ALASKAN WAY VIADUCT

EVALUATION OF GRAY'S RETROFIT PROPOSAL

Prepared for the
Washington State Department of Transportation

By
T.Y. Lin International

Figure 2a, Longitudinal auxiliary frame per Gray's proposal

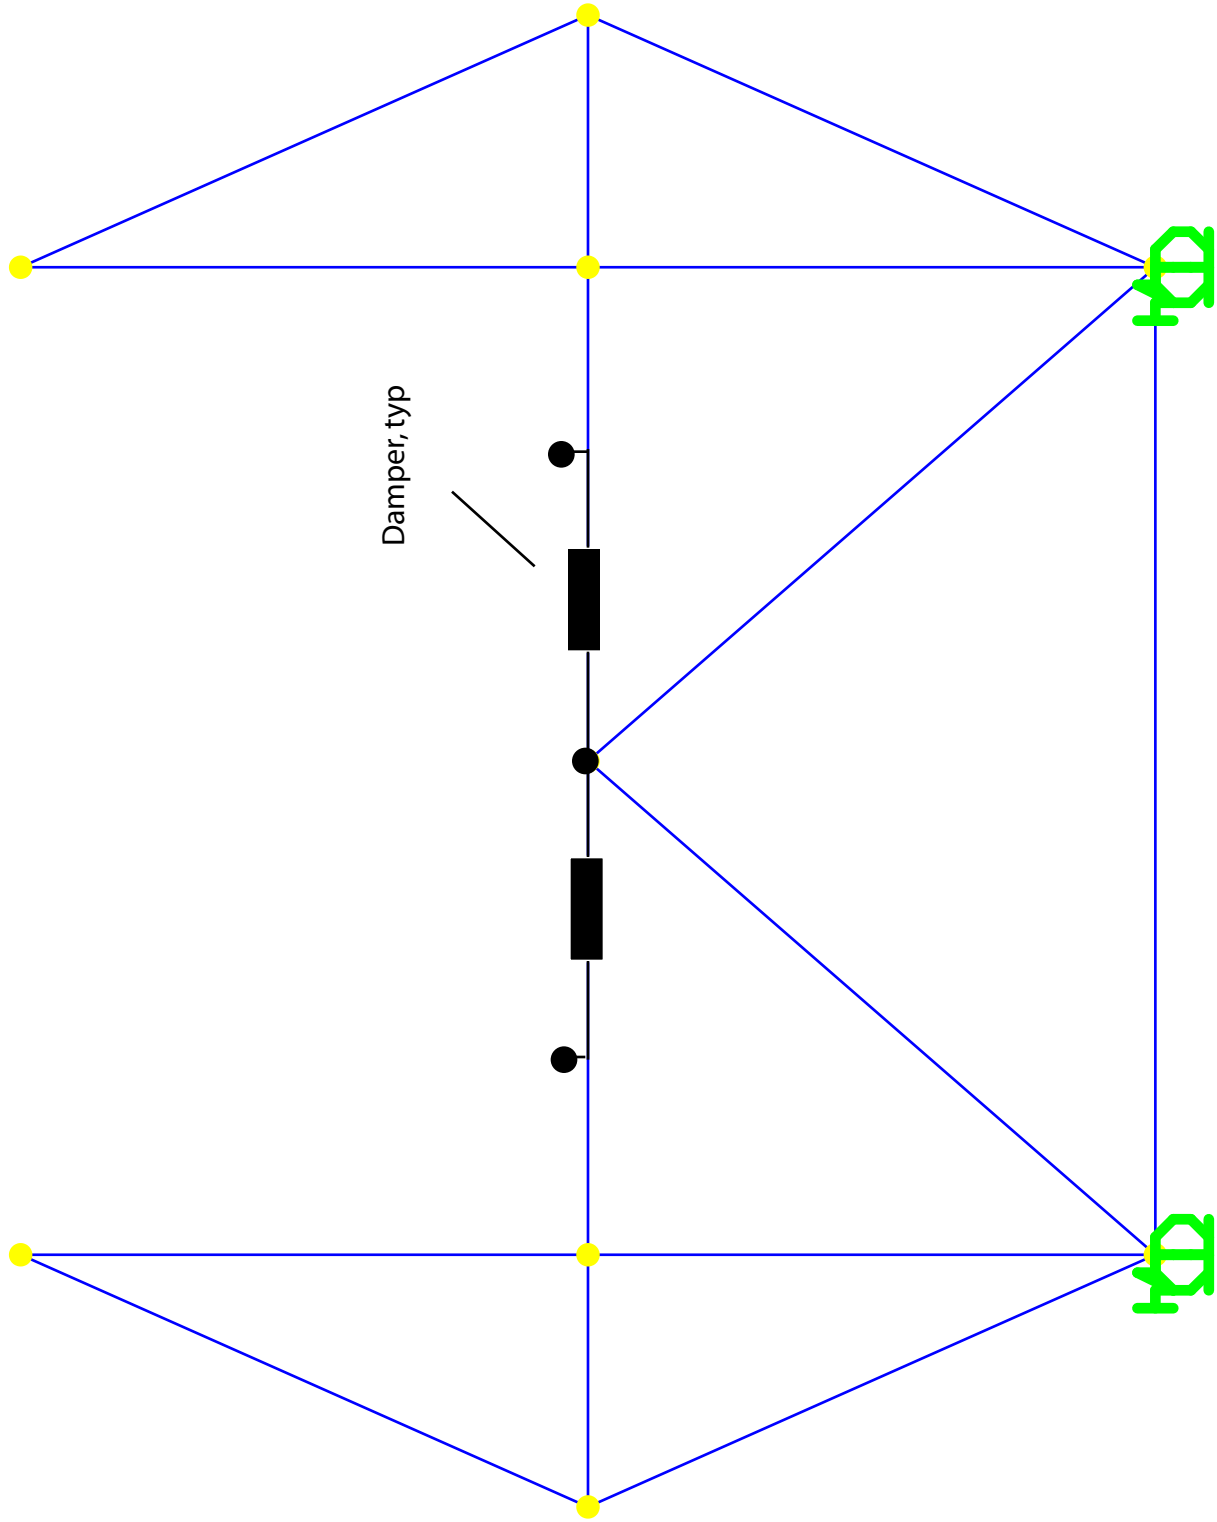
Gray's initial proposal is included in Appendix B of this report. The proposal includes two longitudinal structural steel frames and two transverse structural steel frames per three-bay unit of the structure. Both types of frame are illustrated in Figure 2.

Figure 14a

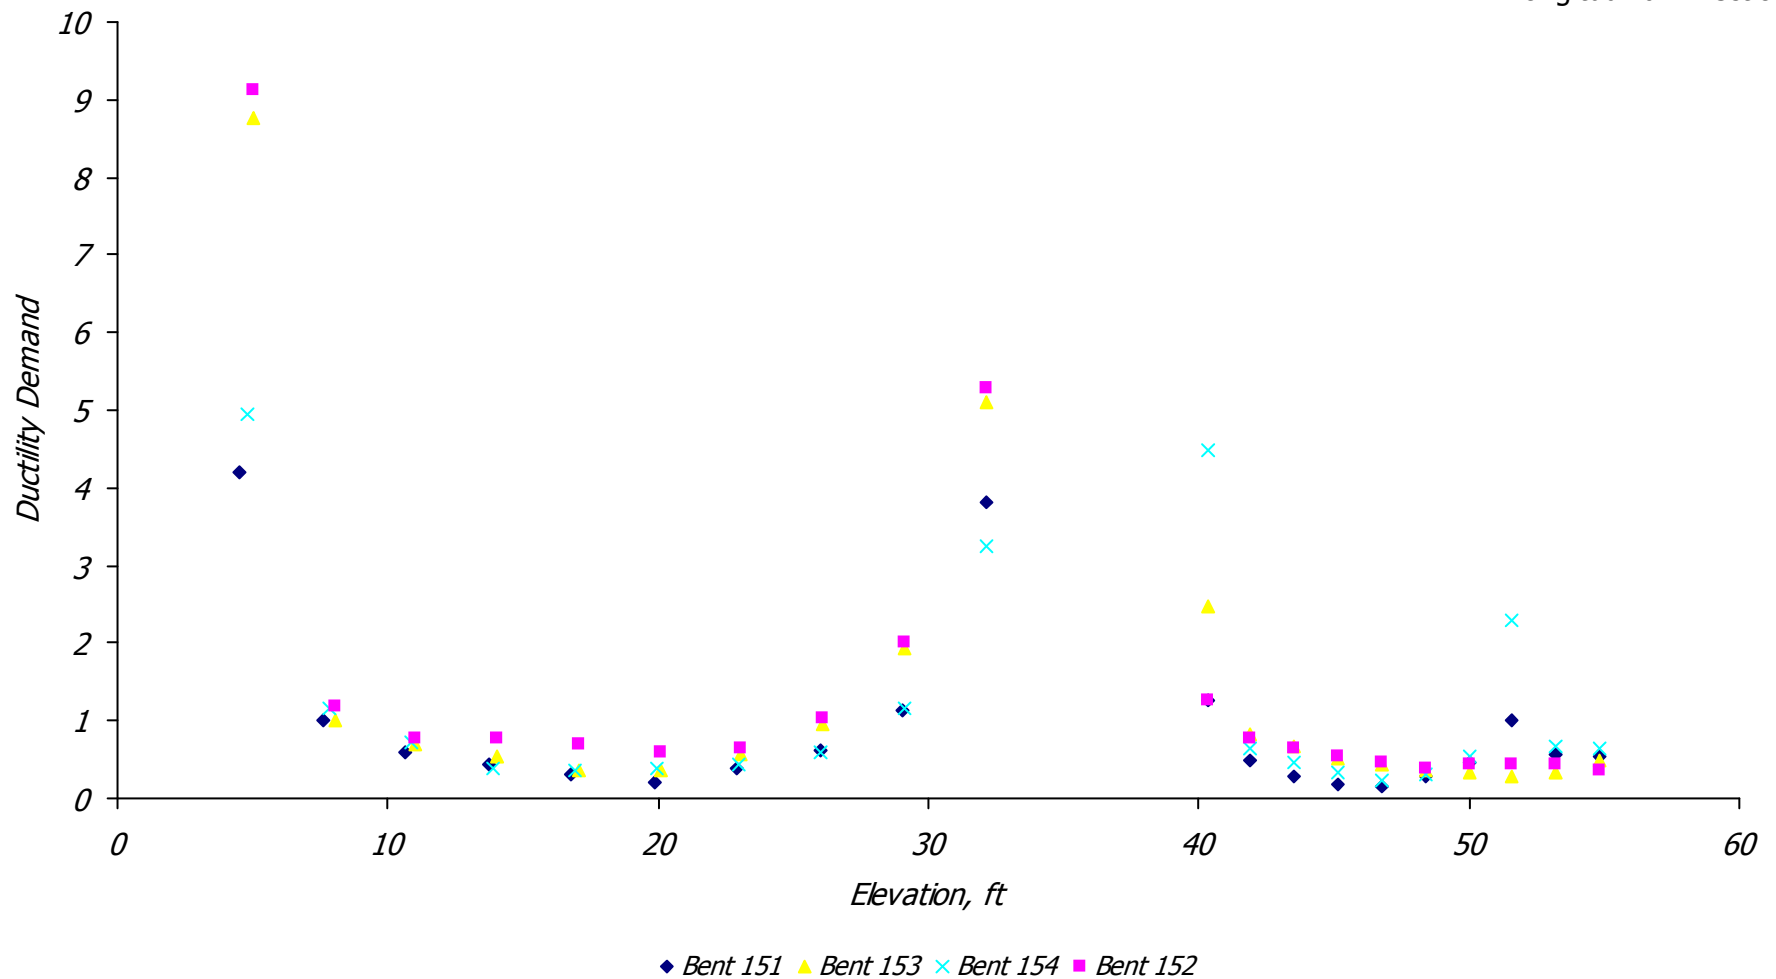
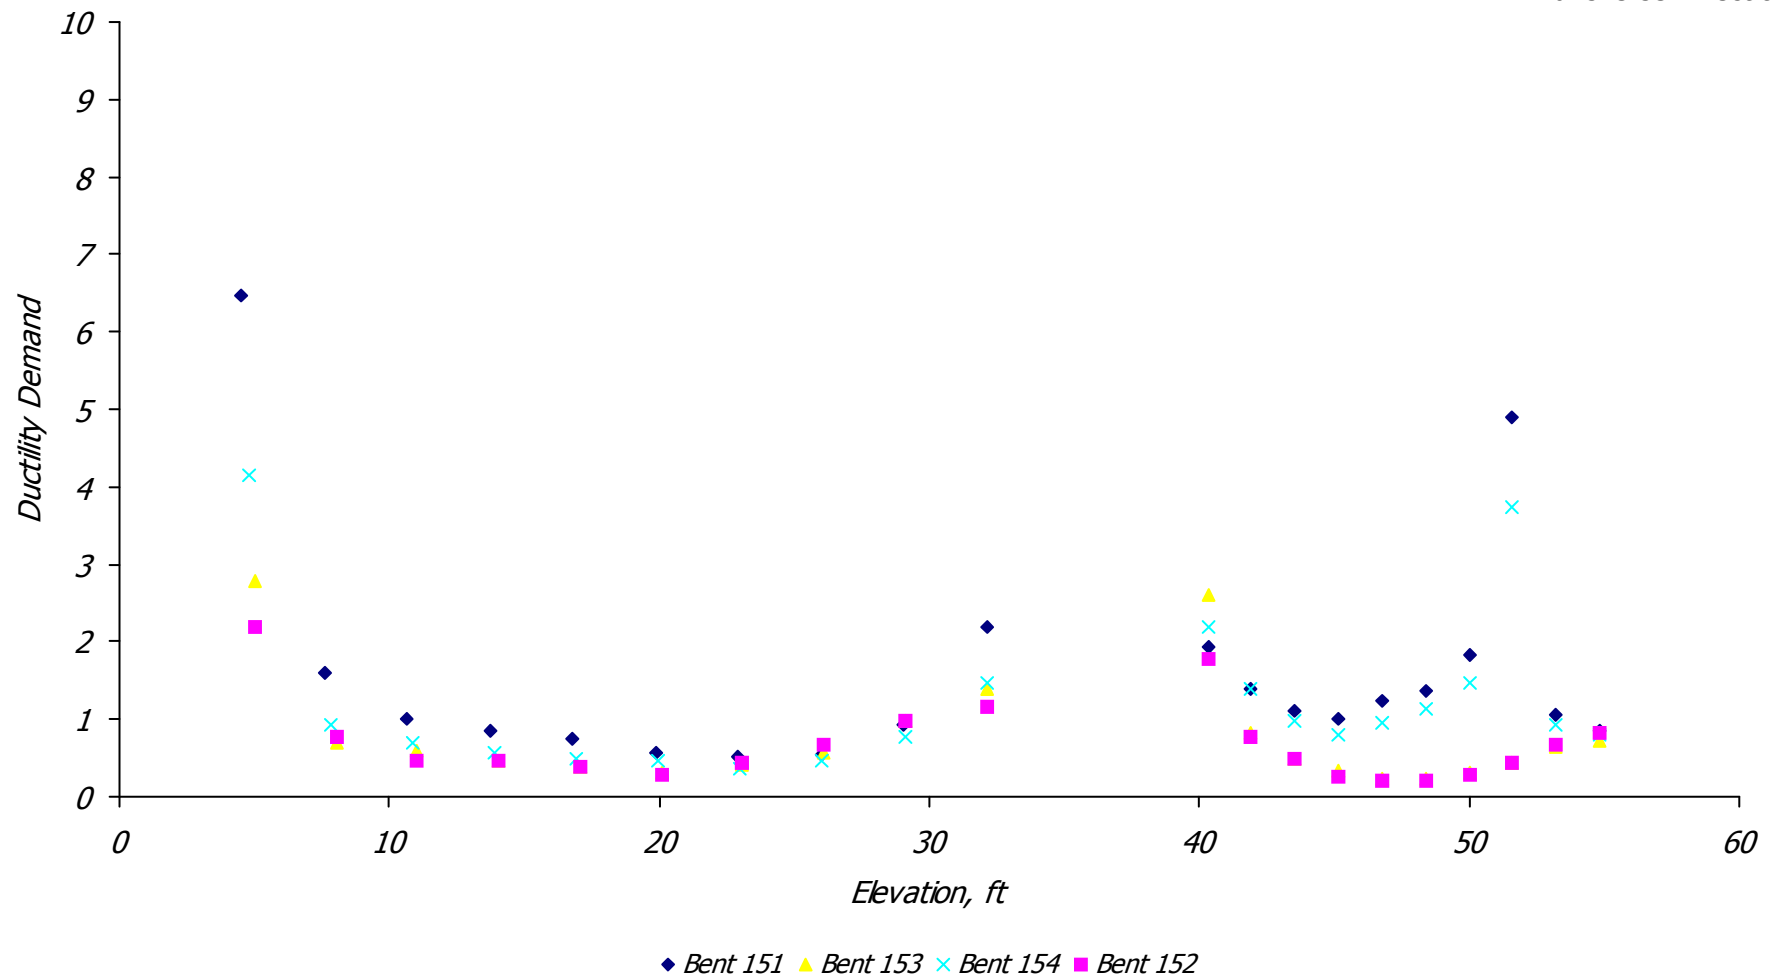
For the rare earthquake, the curvature ductility demands on the columns are summarized in Figure 14. The plots show that plastic hinges form in the tops and bottoms of the columns, in both levels of the structure and in both directions. In the upper level columns of the end bents, the hinges don't form at the very tops of the columns because there is additional main reinforcement at this location. The hinges form at a weaker section a few feet from the tops of the columns.

Figure 15 Column curvature versus axial force, retrofitted structure, rare earthquake, end bents

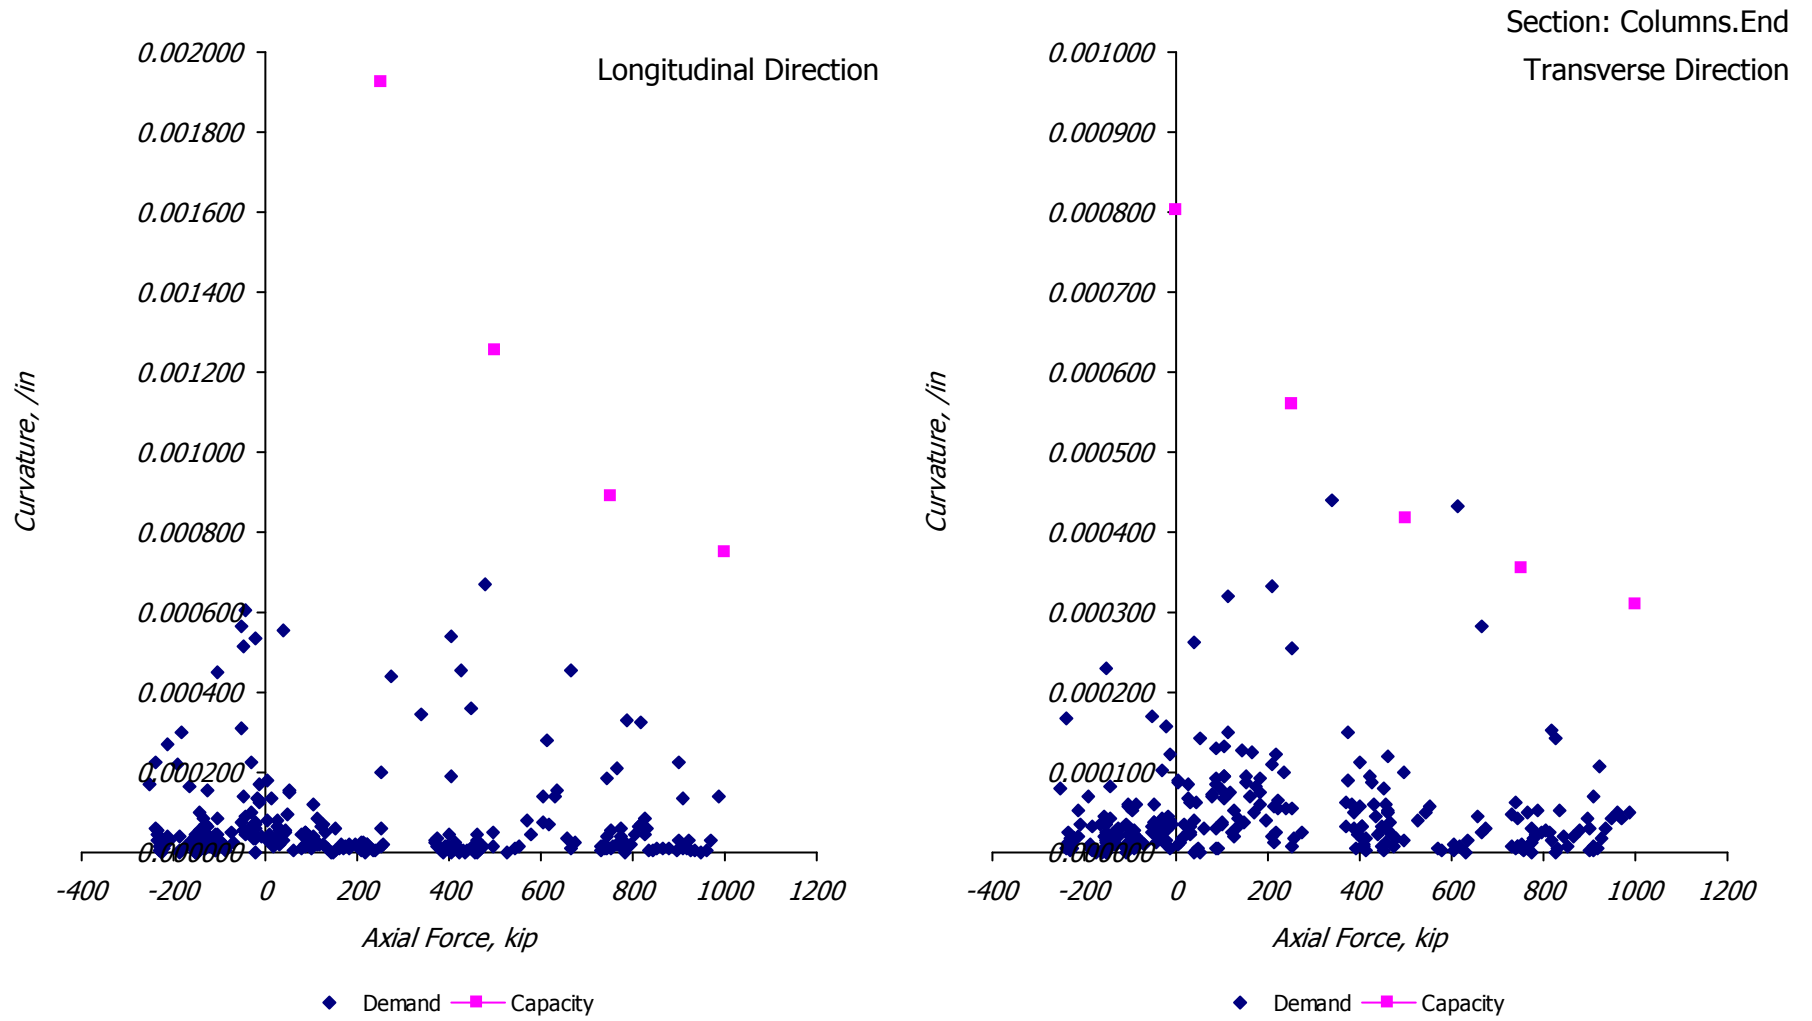
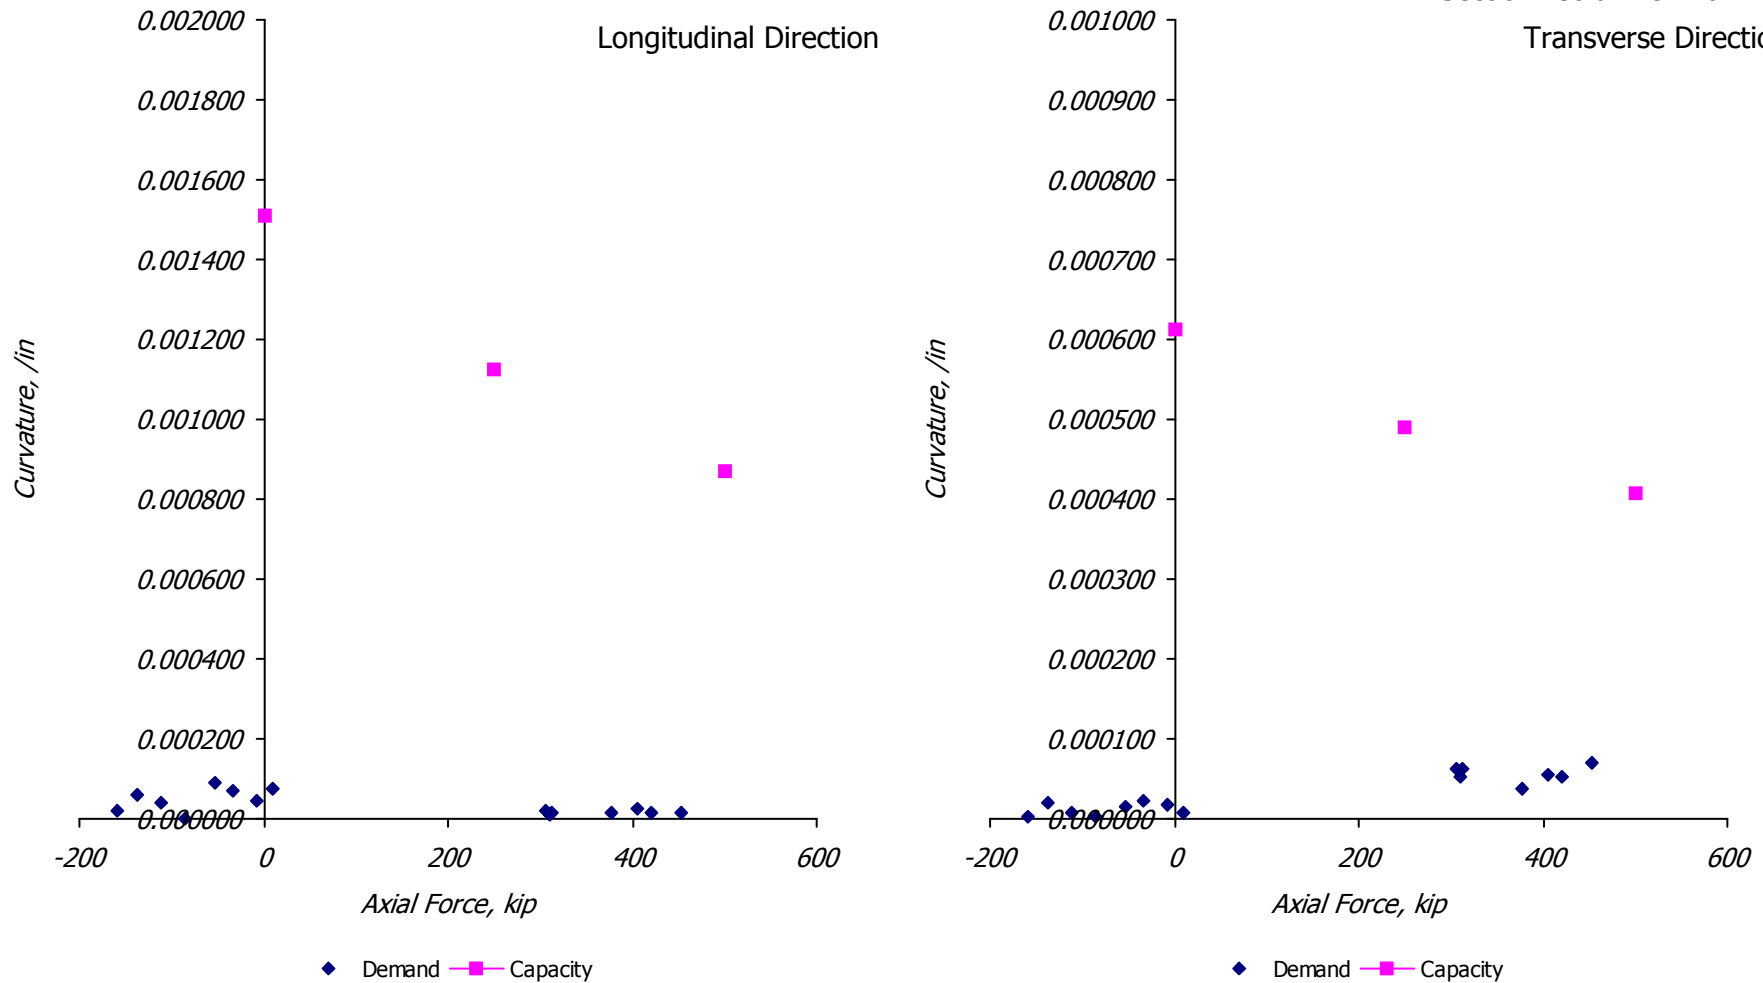
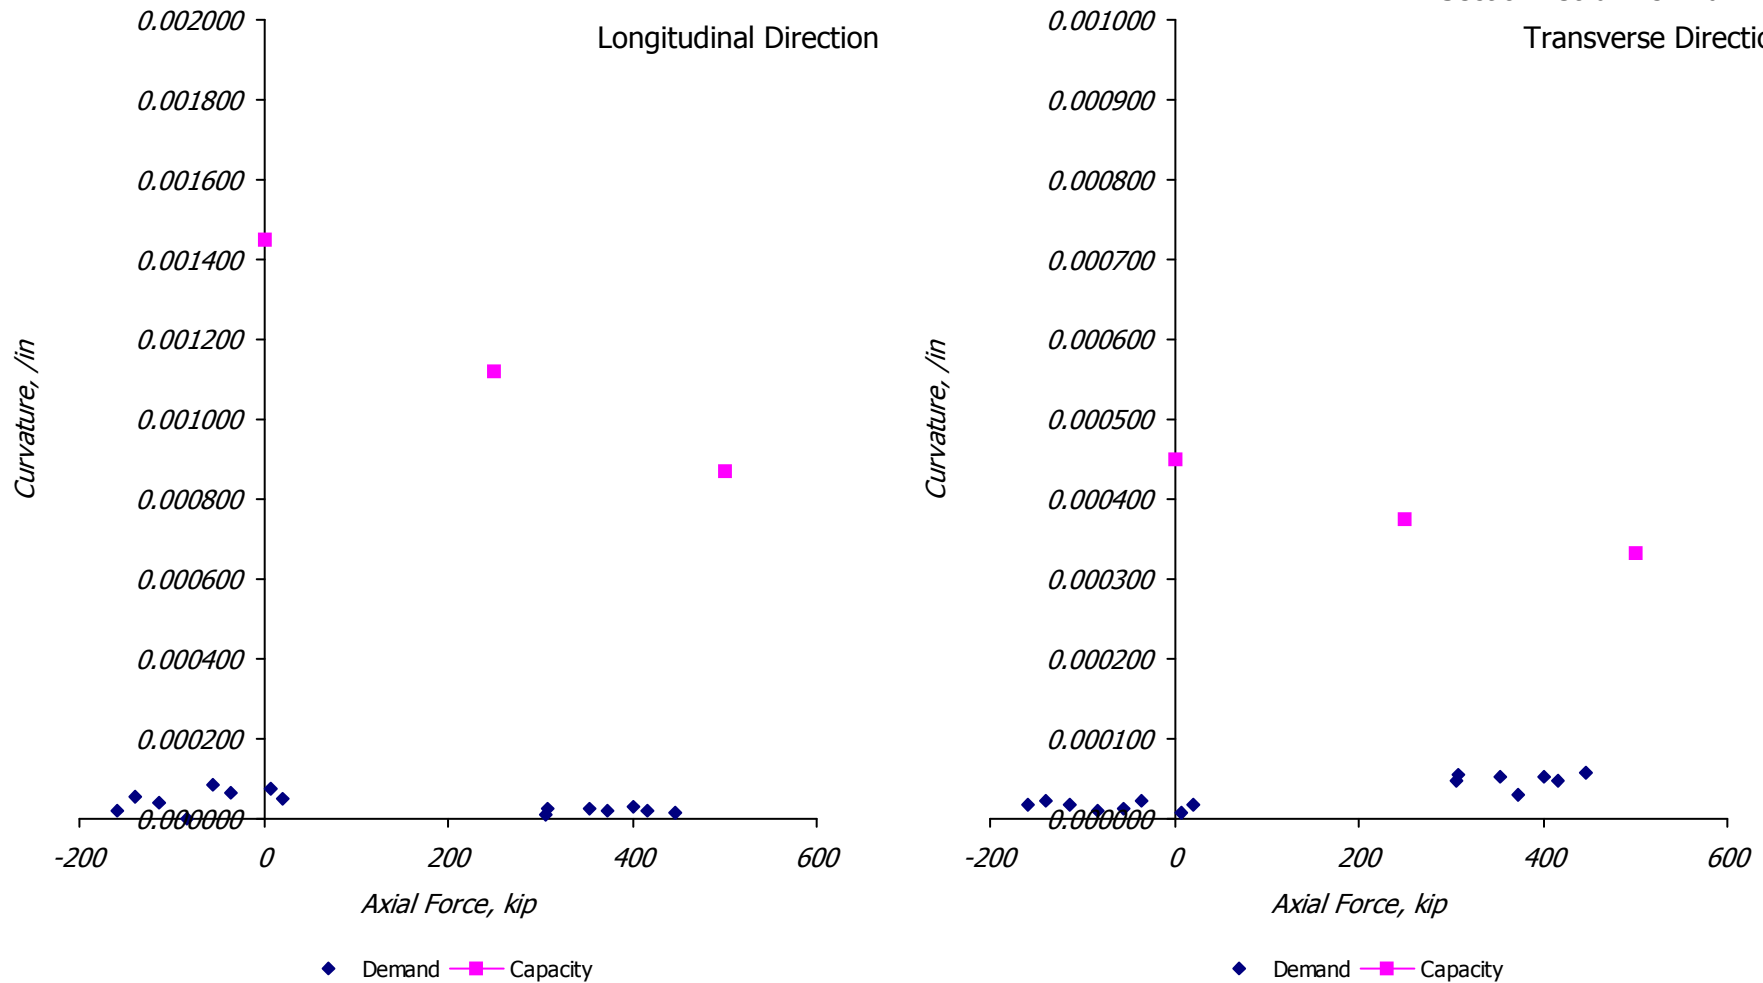
Figure 15 shows that the flexural demands on the end columns slightly exceed the capacity in the transverse direction, for the section designated "Columns.End" (the typical section). Figure 16 shows that the flexural demands on the middle columns slightly exceed the capacity in the longitudinal direction, for the section designated "Columns.Middle" (the typical section). A closer look reveals a more insidious problem, however. The axial forces on the middle columns are very high, over 3500 kip, which is equivalent to a stress of about $0.4f'_c$. These forces are caused by rocking of the structure and impact of the columns and footings against the piles.
